Proposed Change to Appendix A
Technical Specifications to
Operating License DPR-19

Analog Trip System

Revised pages: 3/4.1-8*
3/4.1-9*
3/4.1-10*
B 3/4.1-19*
B 3/4.1-20*
3/4.2-17*
3/4.2-19*
B 3/4.2-32
B 3/4.2-33

Evaluation of Significant Hazards Consideration

Figure 4.2.2.

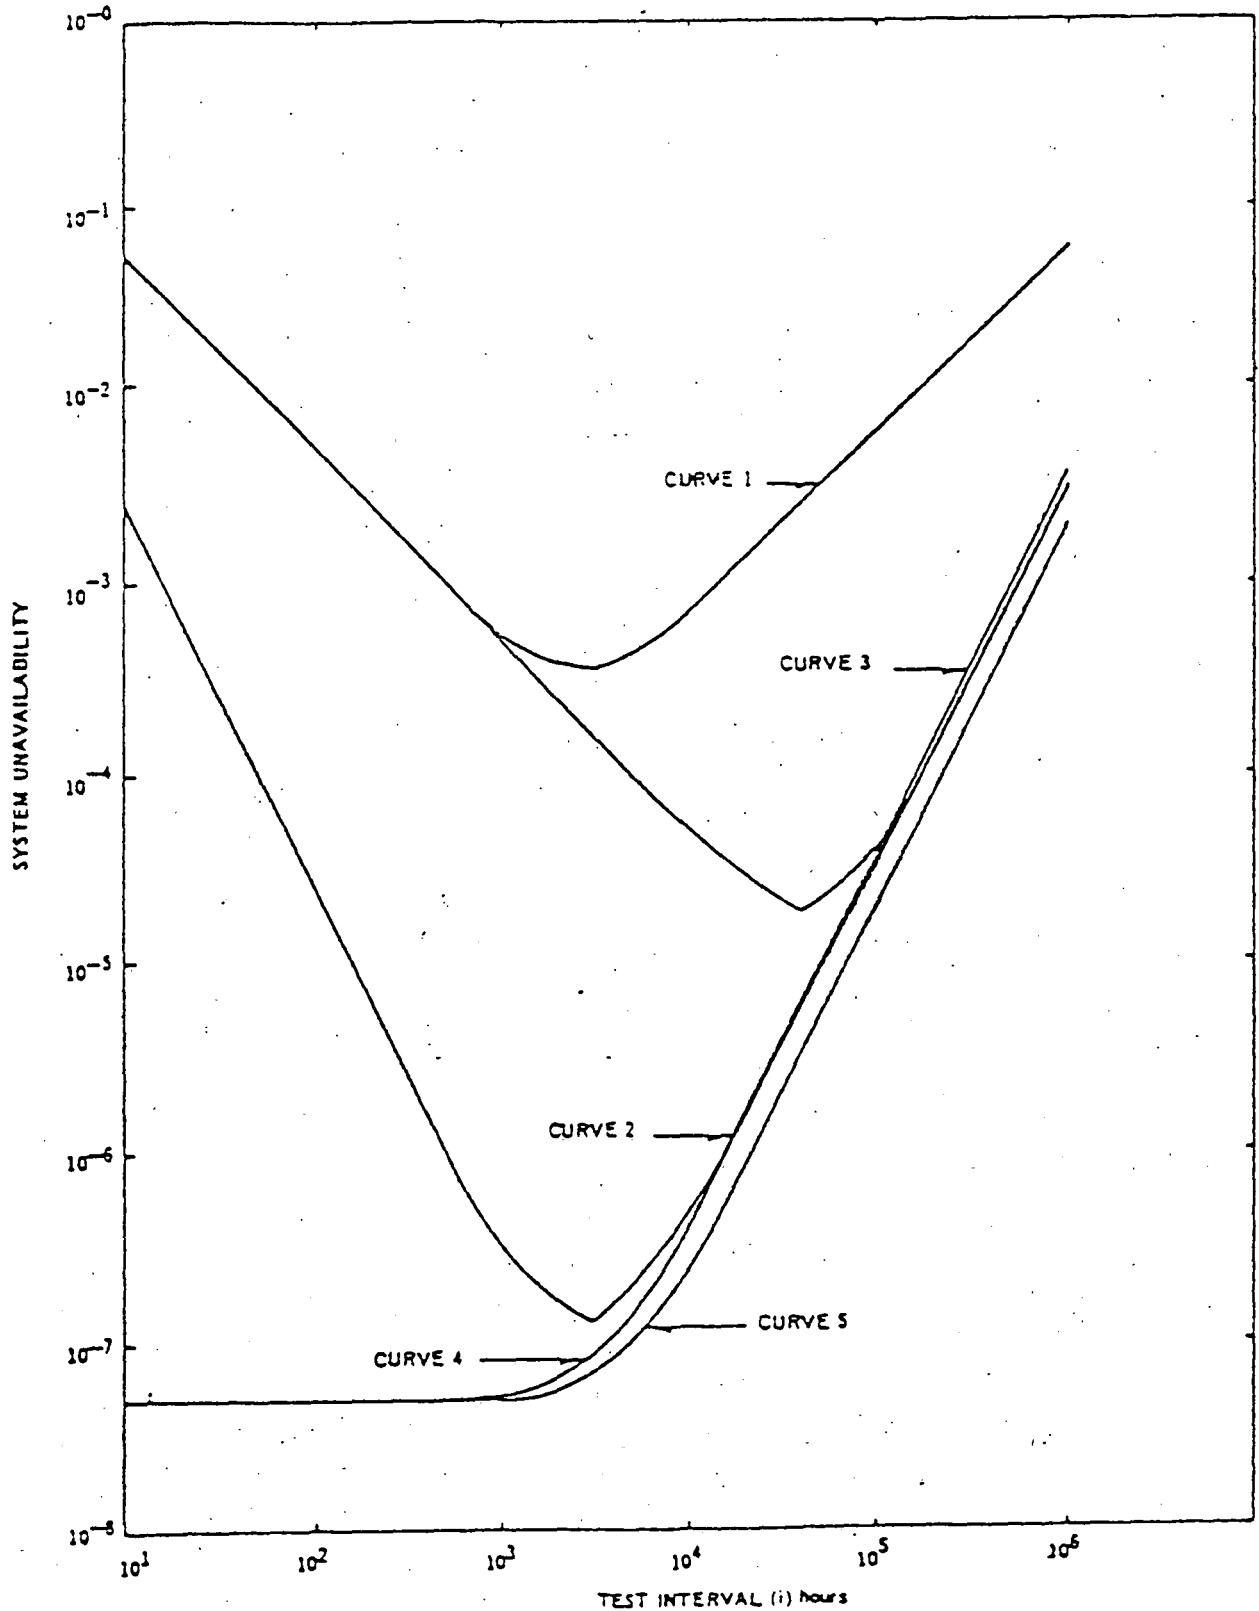
A more usual case is that the testing is not done independently. If both channels are bypassed and tested at the same time, the result is shown in Curve No. 3. Note that the minimum occurs at about 40,000 hours, much longer than for cases 1 and 2. Also, the minimum is not nearly as low as Case 2 which indicates that this method of testing does not take full advantage of the redundant channel. Bypassing both channels for simultaneous testing should be avoided.

The most likely case would be to stipulate that one channel be bypassed, tested and restored, and then immediately following the second channel be bypassed, tested, and restored. This is shown by Curve No. 4. Note that there is no true minimum. The curve does have a definite knee and very little reduction in system unavailability is achieved by testing at a shorter interval than computed by the equation for a single channel.

The best test procedure of all those examined is to perfectly stagger the tests. That is, if the test interval is four months, test one or the other channel every two months. This is shown in Curve No. 5. The difference between Cases 4 and 5 is negligible. There may be other arguments, however, that more strongly support the perfectly staggered tests, including reductions in human error.
